# BUILDING CODE OF AUSTRALIA ASSESSMENT REPORT

Project: Block 3A, Central Park

Client: Frasers Broadway Pty. Limited  
Report: 121997.1  
Date: 31 October 2012

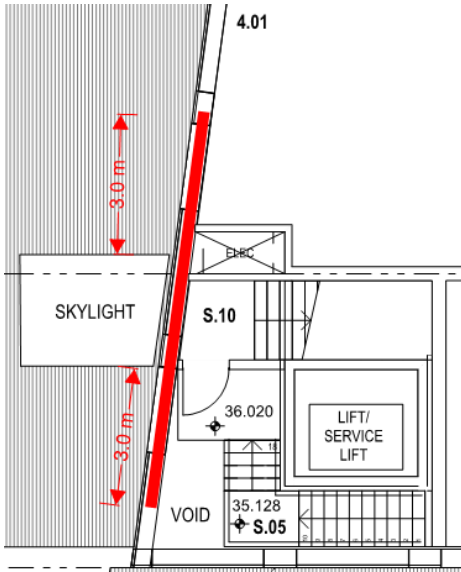
C3.3	Separation of external walls and associated openings in different fire compartments	<p>The northern and southern external window openings of the meeting rooms / restaurants and the residential apartments on levels 1 &amp; 2 are located less than 6m from each other and both are required to be protected in accordance with C3.4 of the BCA.</p>  <p>Where protection is not proposed, justification would be required under the performance requirements of the BCA via a fire engineered alternative solution.</p>	The proposed building is capable of complying
